Change Order, Construction Manager as Adviser Edition

PROJECT: (name and address)
Christian County High School
5185 Fort Campbell Blvd
Hopkinsville, KY 42240
OWNER: (name and address)
Christian County Board of Educ

Change Order Number: 087 Date: October 07, 2025

PROPOSAL REQUEST

A1.1F Rev2

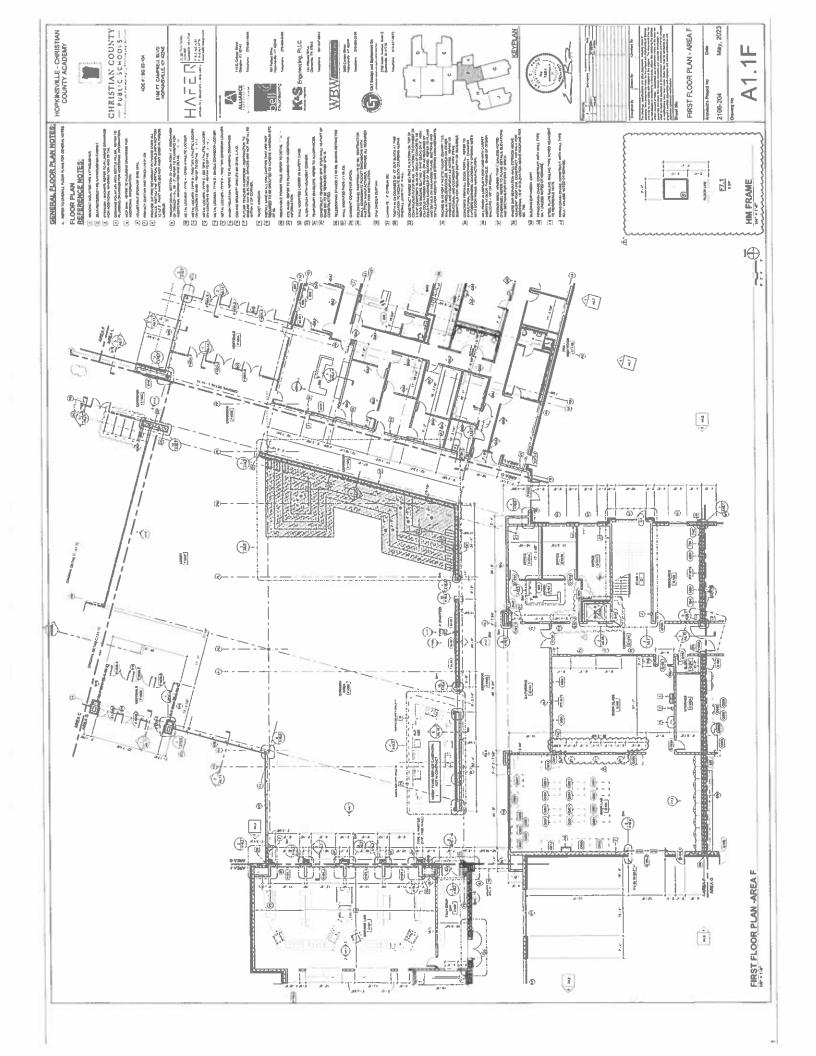
G102 Interior Windows

- Provide a price to provide to:
 - Saw Cut openings for three new windows between G102 and G104. Verify dimensions so data feed from above to G102 will not be severed.
 - Provide three new windows similar to W7, but with 8 ¾" depth on knockdown frames for ease of installation and to cover cut edges of CMU
 - Paint window frames.
 - Provide back to back 3 ½" x 3½" x ¼" steel angle lintel at header, bearing 8" each side.
